Dulwich Community Council

14. Paxton Green Roundabout Improvements

Item No. 14.	Classification: Open	Date: 30 January 2013	Meeting Name: Dulwich Community Council
Report title:		Paxton Green Rou	ndabout Improvements
Ward(s) or groups affected:		College Ward	
From:		Strategic Director of Environment and Leisure

London Borough of Southwark Paxton Green roundabout improvements Public Consultation Summary

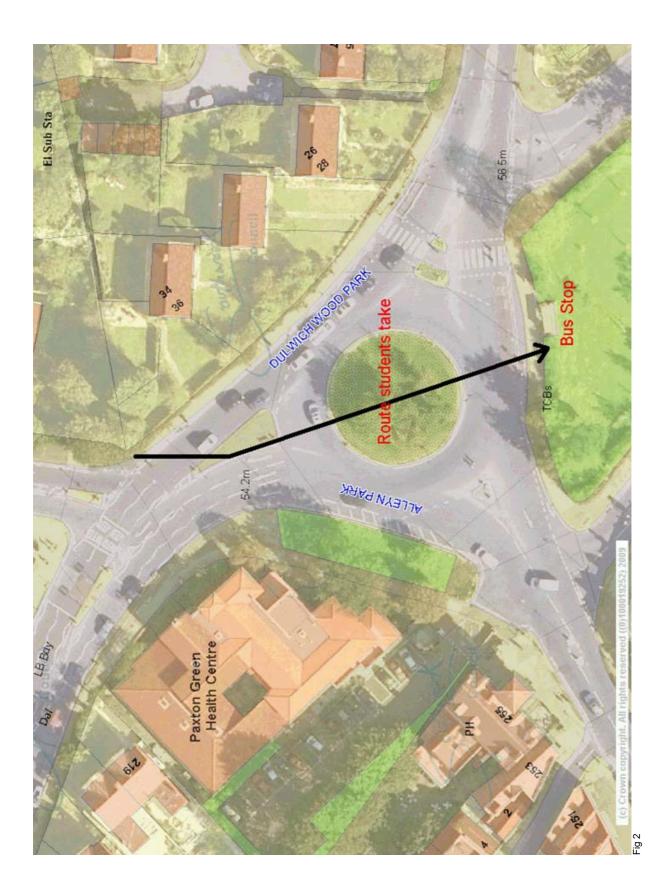
Road and directly across the Paxton Roundabout (illustrated in fig2). This often happens when students see that the number 3 bus is 1. Paxton Roundabout. Students ignore the official road crossings that are in place and take a dangerous route across Alleyn already at the stop and are anxious not to miss it. It is this behaviour that needs to be tackled.

The school have requested that guardrails be put in place at the bottom of Alleyn Park road so that the route straight across the roundabout to the bus stop is not such a quick and easy option.

- Would guardrails be suitable at this site?
- b i. Would planting/landscaping the traffic island and or roundabout (Some thorny hedges for example) to make If guardrails are deemed inappropriate what other solutions would be the best way of combating the problem? crossing more difficult be an option? Who would we need to consult/seek approval from on this? . D

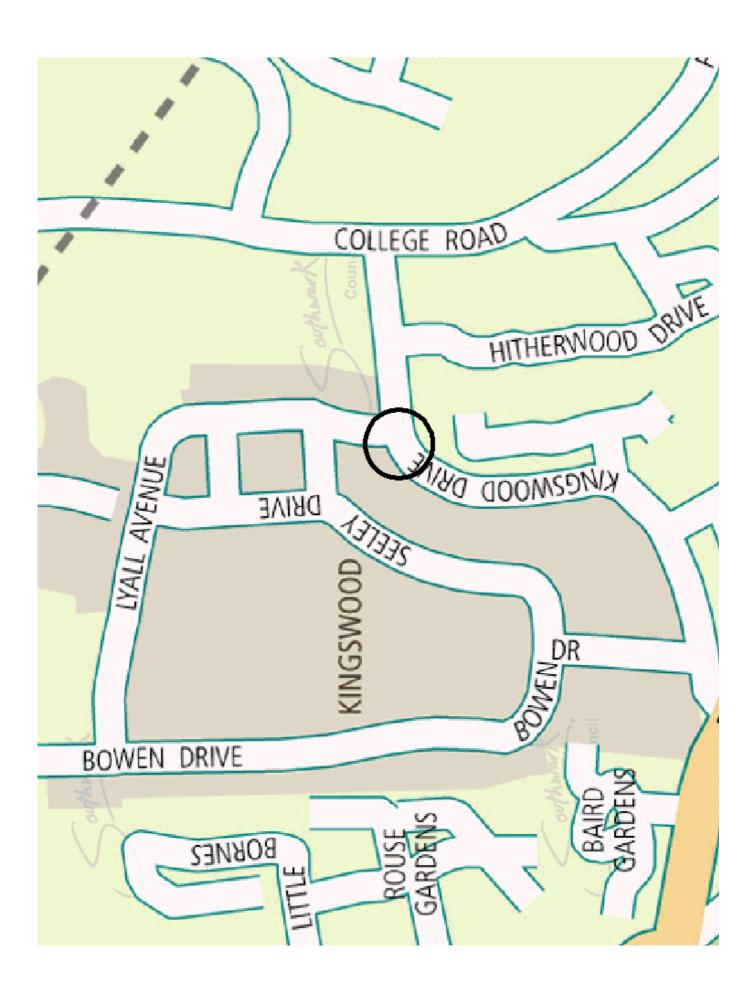
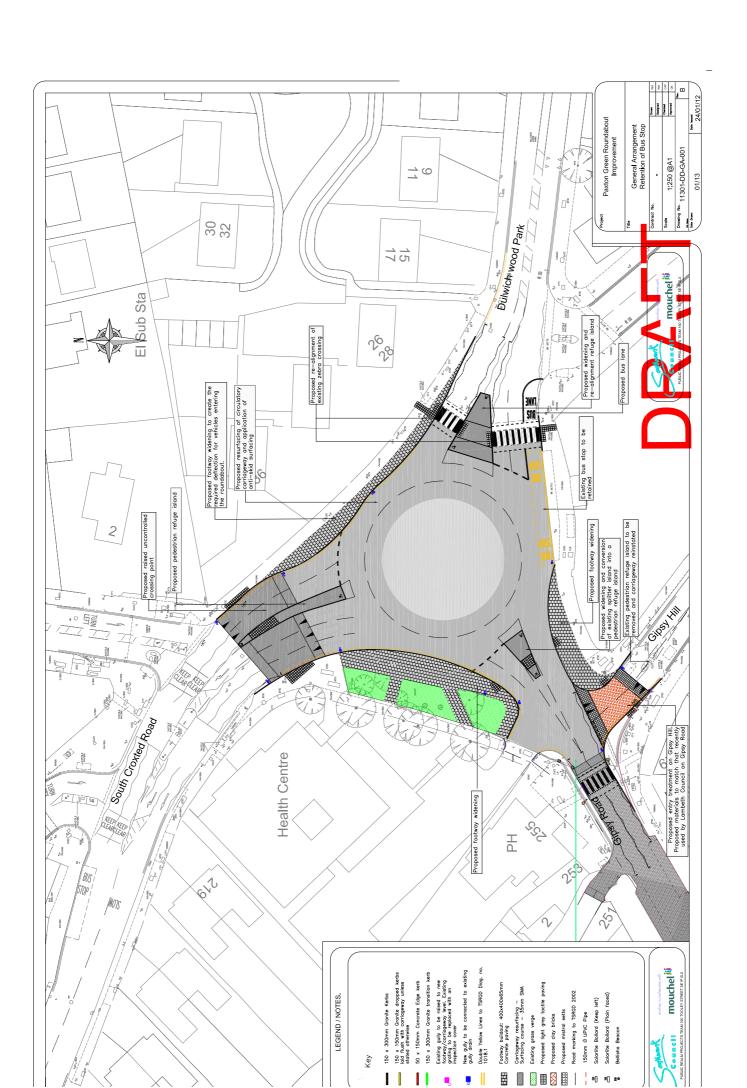
b ii. How feasible would it be to move the current bus stop or create a new stop on South Croxted Road, which would be in a more convenient location for students to use the existing crossing? Again who would we need to consult/seek approval from on this?

2. College Road. Students walking to Sydenham Rail Station via Rock Hill cross College Road on a diagonal (see fig 3 for crude desire line drawing). The school feel that this is a road which has poor sight lines and carries fast moving traffic. The same issue exists at the top of Rock Hill as well. What measures can be put in place to make the crossings safer for students? 11-1 11 1 Fig 3
